City of Plymouth Planning Commission

Regular Meeting Agenda

PULTE HOMES OF MICHIGAN, LLC
 PLYMOUTH MULTI-FAMILY
 AMENDED PRELIMINARY PUD PLAN

Site Plan Review - Amended PUD Plans

PULTE HOMES OF MICHIGAN, LLC
PLYMOUTH MULTI-FAMILY
AMENDED PRELIMINARY PUD PLAN
STORMWATER MANAGEMENT PLAN

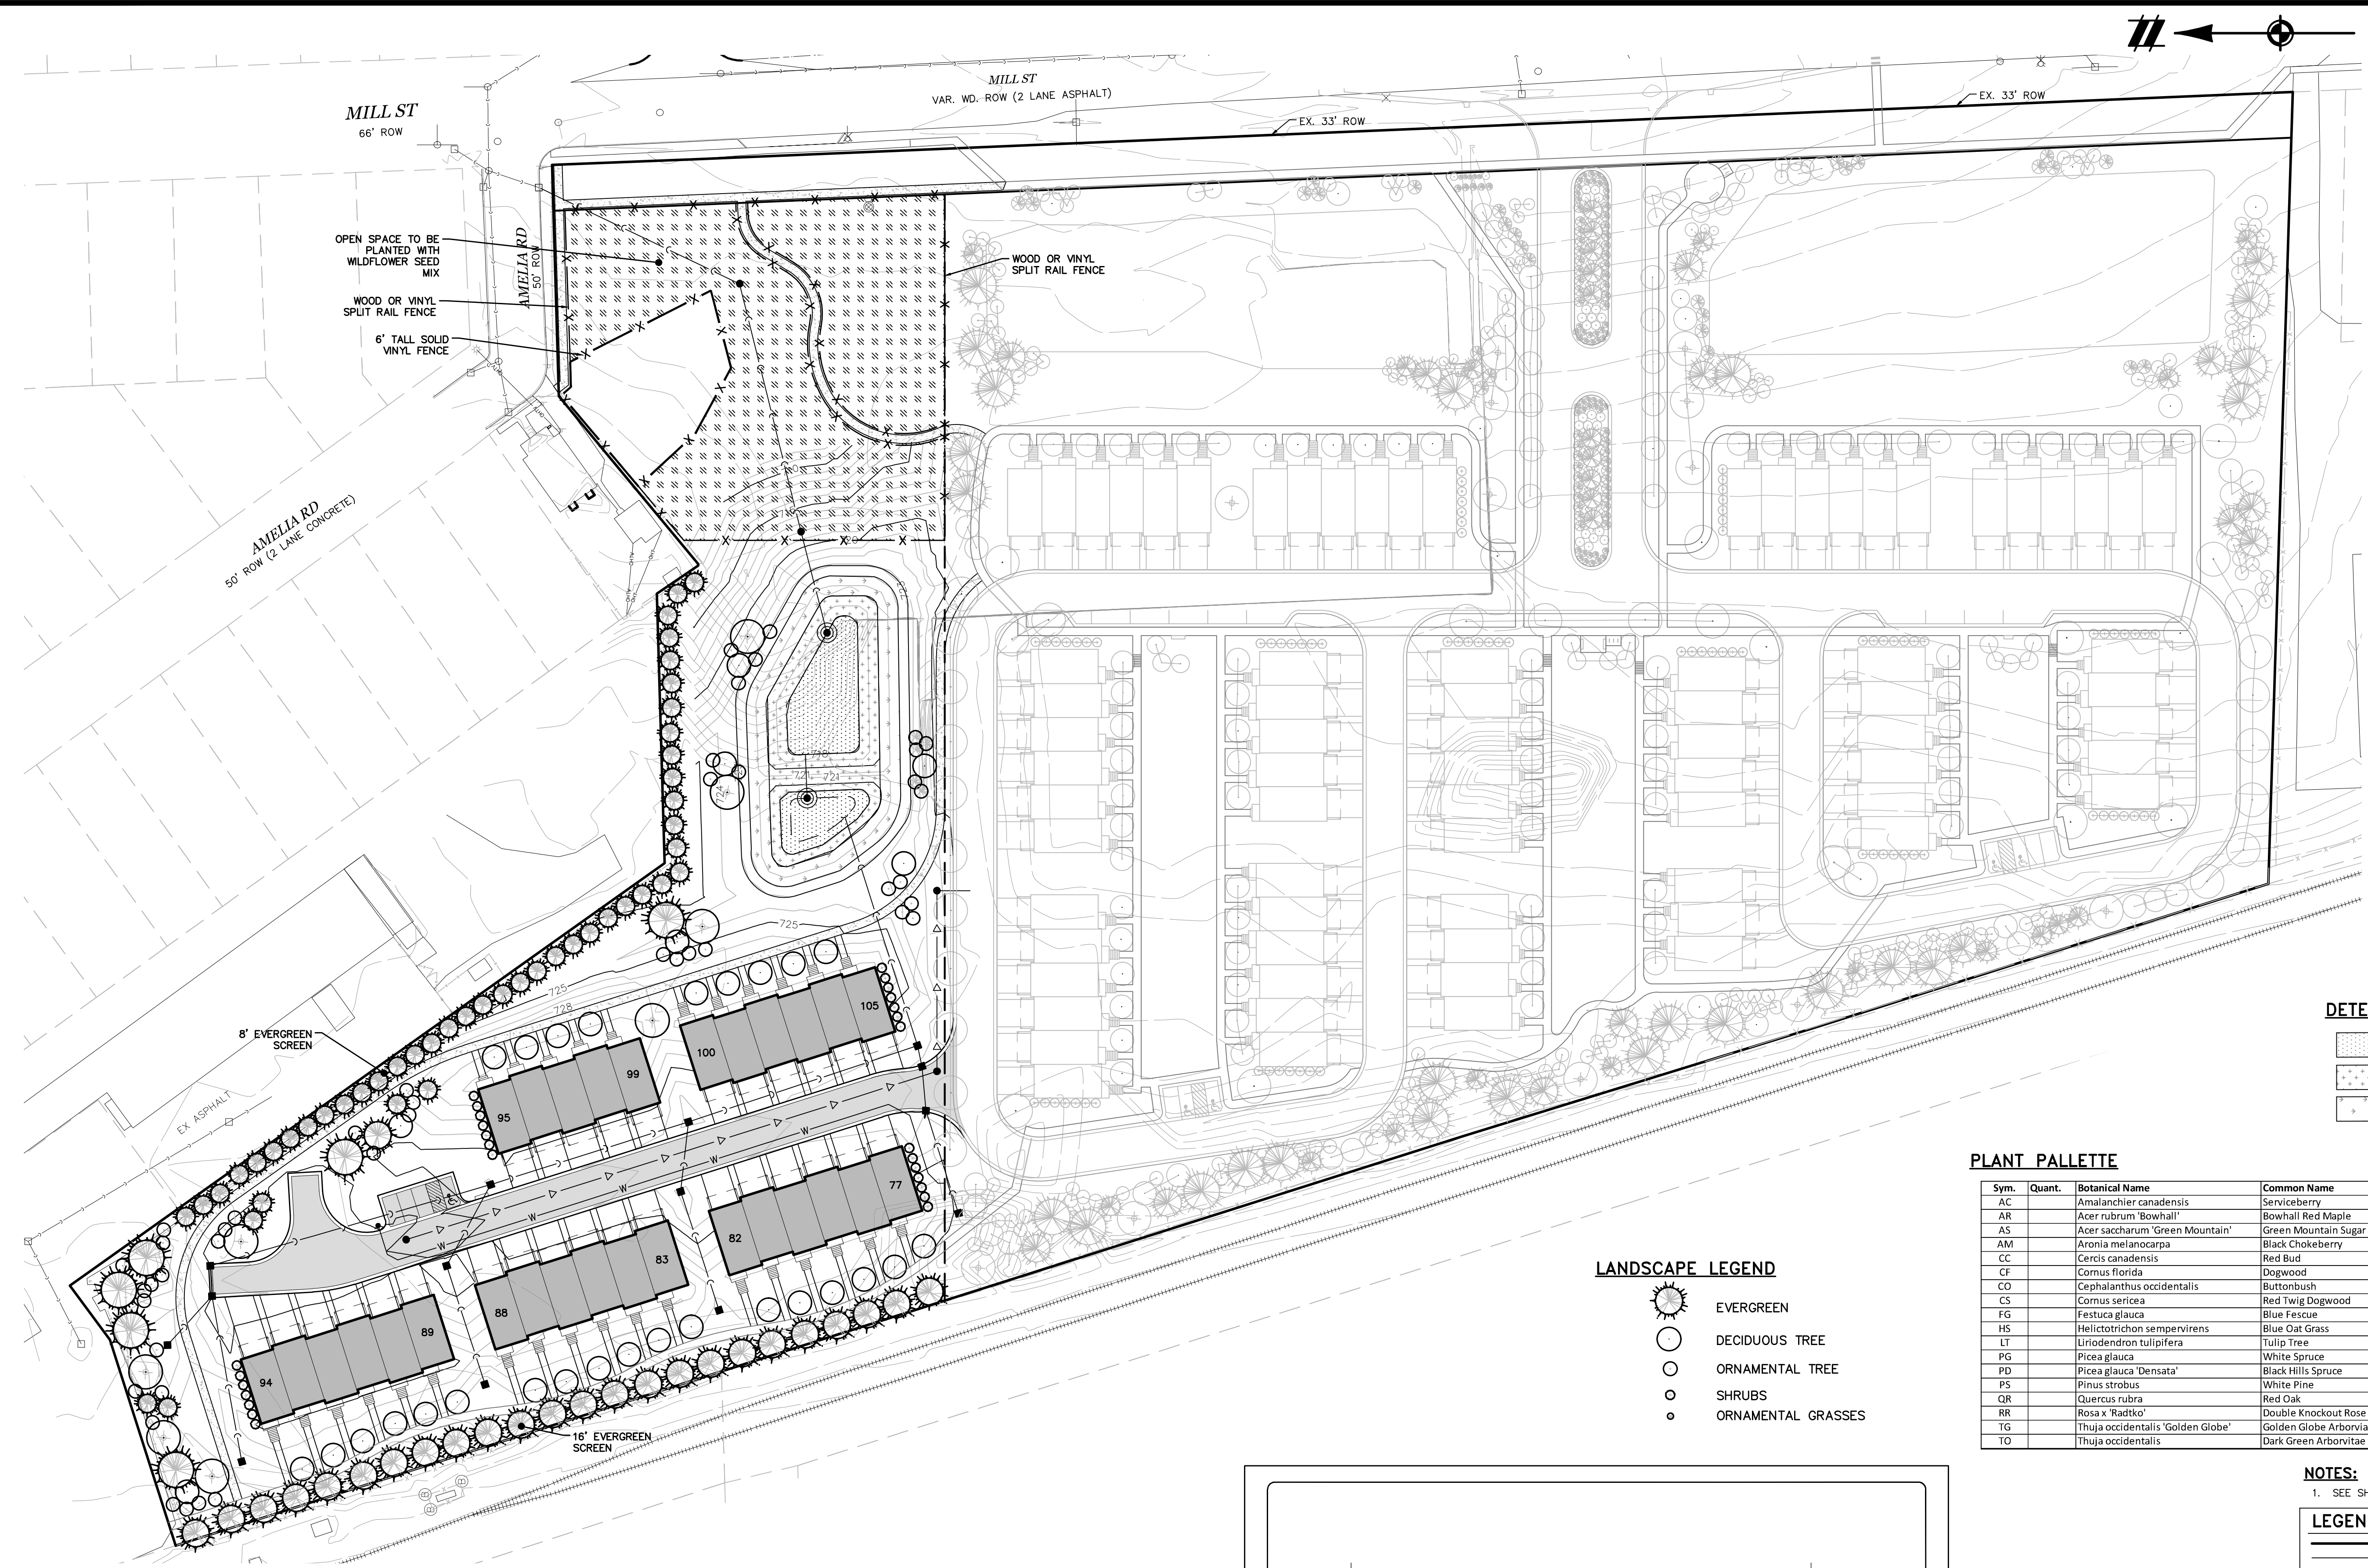
1. The plans propose a storm water management system that is unique to serve the northern portion of the project area (approximately 4 acres). The proposed storm water system includes a proposed connection to a city storm sewer manhole in the Amelia Road right of way. The storm water management calculations that have been provided will be reviewed as part of the detailed engineering review but are acknowledged as being submitted.
2. The city would prefer to have this new detention system outlet to either the Wayne County storm sewer system in Mill Street or through the storm water management system that was permitted under the original project. We would recommend that the developer and city meet to discuss this portion of the proposed storm water system prior to approval of the Final PUD Amendment.
